CTI# 5000, 5001, 5060, 5061, 5099 AutoYoke

A change has been made to the AutoYoke regarding the Tilt Motor Mount and Pan Motor Mount.

Figure 1: New Tilt Motor Mount

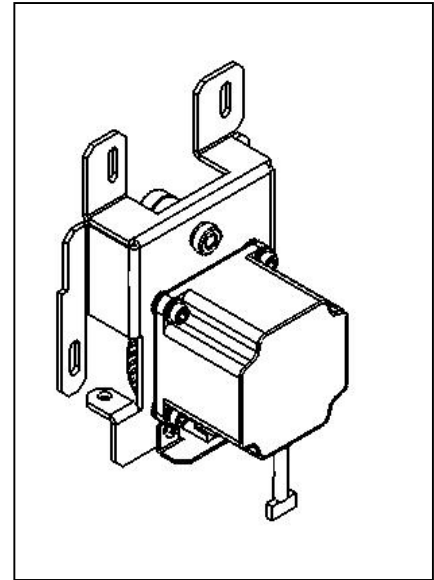
The new tilt motor mount is shown in Figure 1. It will mount into any yoke with the same 4 nuts and washers, and is tensioned in the same way using the same hardware.

Figure 2: New Pan Motor Mount

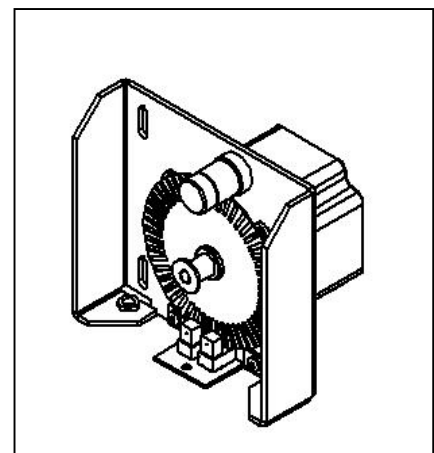
The new pan motor mount looks like the pictured in Figure 2. It will also mount into any yoke with the same mounting hardware and tensioning hardware.
